SOUTH CAROLINA ELECTRIC & GAS COMPANY

Subject: Virgil C. Summer Nuclear Station
Docket No. 50/395
Earthquake Instrumentation

In our May 3, 1982, letter South Carolina Electric and Gas Company described a change in location of the triaxial peak accelerograph located in the reactor building. A commitment was made to provide an FSAR revision to show the exact revised location. The attached marked up pages provide that information. They will be incorporated in the next FSAR amendment.

Figure 3.7-49

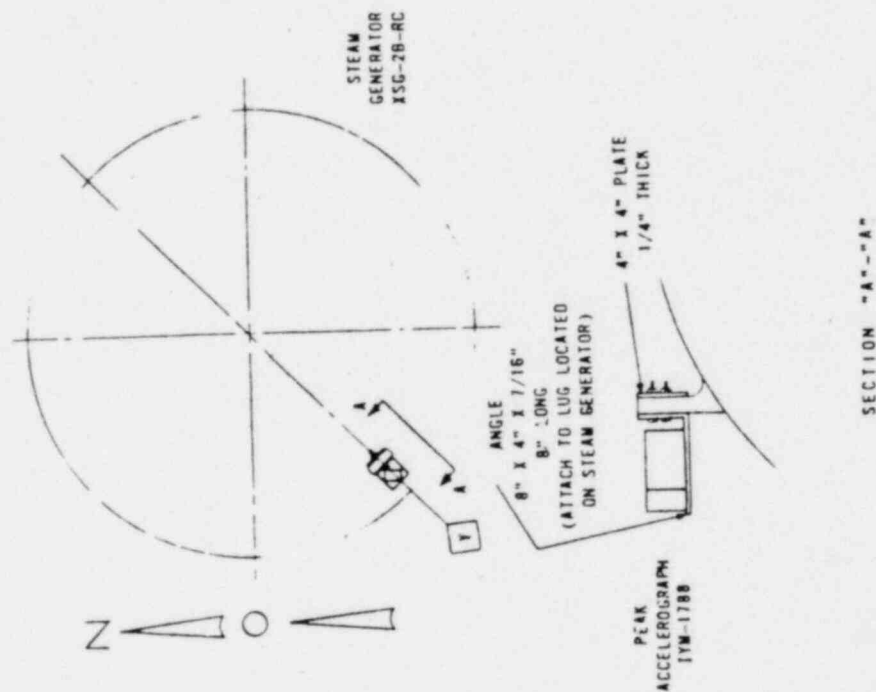
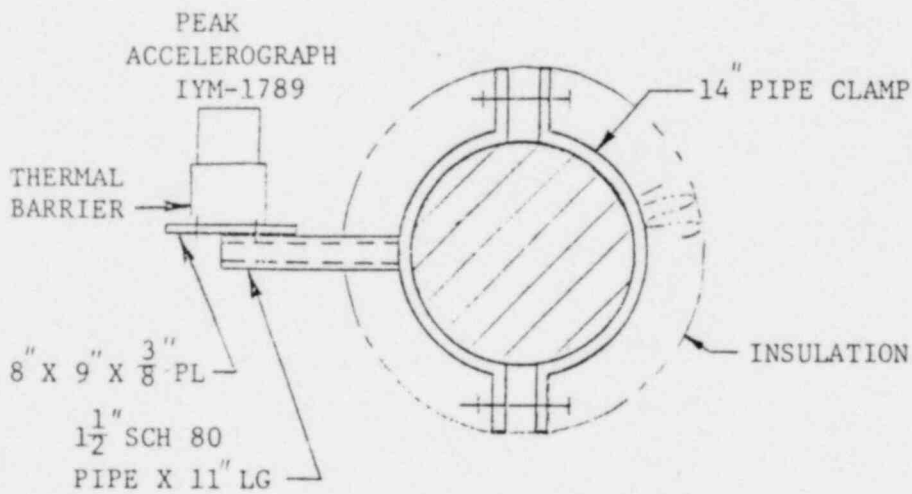
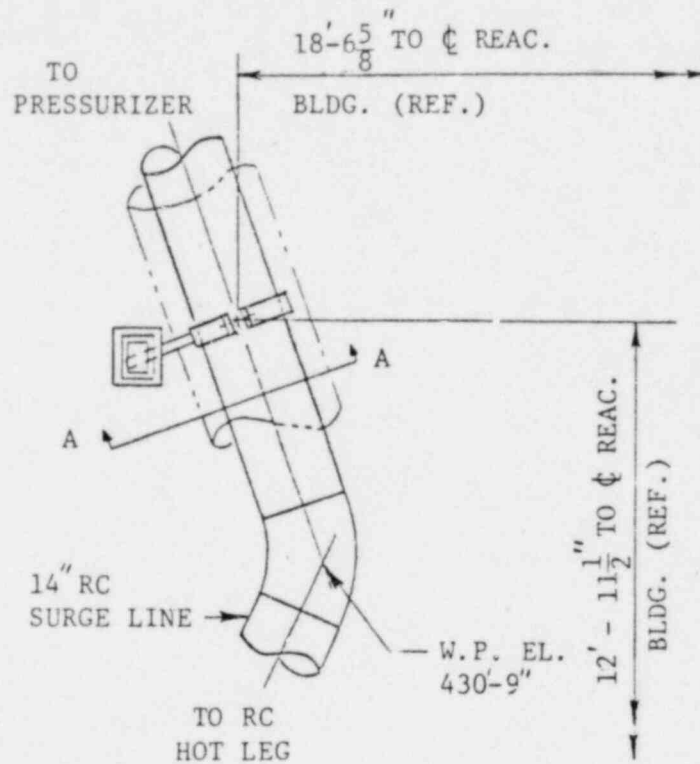
- 32 |
- a. On the top of the steam generator, as shown by Figure 3.7-49.
 - b. ON THE PRESSURIZER SURGE LINE,
~~At the bottom of the reactor vessel, on the tubing,~~ as shown by Figure 3.7-49.
 - c. On the residual heat removal system heat exchanger (see Figure 3.7-50).

REPLACE WITH SKETCH ATTACHED

Seismic Instrumentation On
Top of Steam Generator And
~~Bottom of Reactor Vessel~~
PRESSURIZED SURGE LINE

4. This instrument is located at a nodal point in the piping stress analysis which has calculated thermal movements, accelerations and displacements
